Reconstruction Era National Historical Park Accessibility Assessment

Summary Report

Gary Everhardt Park Break Program

July 2023

Brief Description: Lower urinal unit

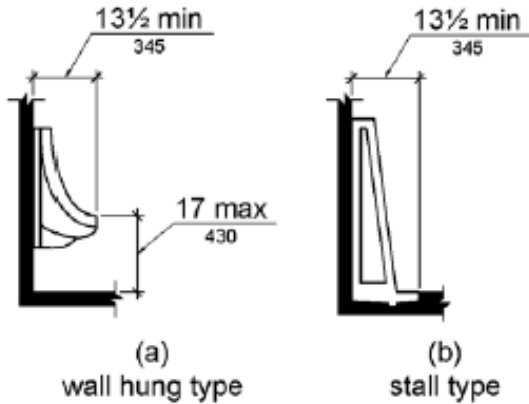
Deficiency: The wall hung urinal in the men's restroom at the Darrah Hall Men's Restroom area exceeds maximum height requirements of 17 inches maximum at 23½ inches above the finish floor to the top of the rim. In addition, the flush handle is 53 inches tall, which does not meet accessibility requirements.

Recommendations: Remove and lower the wall hung porcelain urinal so that the rim is 17 inches maximum above the finish floor. Ensure during reinstallation that the depth of the urinal, measured between the wall and outer surface of the rim, is maintained at 13½ inches minimum.

Brief Description: Lower fire extinguisher

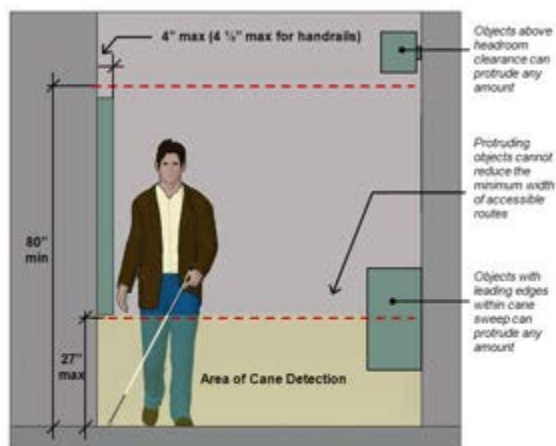
Deficiency: The bottom of the fire extinguisher was measured at 30 inches above the floor and 5½ inches away from the wall, protruding into the path of travel. A protruding object is an accessibility deficiency when the object protrudes more than 4 inches into the path of travel above 27 inches from the finished floor or ground surface.

Recommendations: Remove the fire extinguisher from the wall and lower it so that the bottom of the fire extinguisher is no higher than 27 inches from the floor. Objects with leading edges more than 27 inches and not more than 80 inches above the finish floor or ground shall protrude 4 inches maximum horizontally into the circulation path. When a cane is used and the element is in the detectable range, it gives a person sufficient time to detect the element with the cane before there is body contact.

Brief Description: Lower fire extinguisher

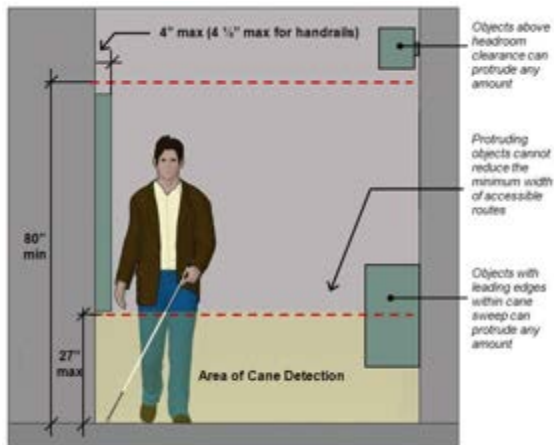
Deficiency: The bottom of the fire extinguisher was measured at 30 inches above the floor and 5½ inches away from the wall, protruding into the path of travel. A protruding object is an accessibility deficiency when the object protrudes more than 4 inches into the path of travel above 27 inches from the finished floor or ground surface.

Recommendations: Remove the fire extinguisher from the wall and lower it so that the bottom of the fire extinguisher is no higher than 27 inches from the floor. Objects with leading edges more than 27 inches and not more than 80 inches above the finish floor or ground shall protrude 4 inches maximum horizontally into the circulation path. When a cane is used and the element is in the detectable range, it gives a person sufficient time to detect the element with the cane before there is body contact.
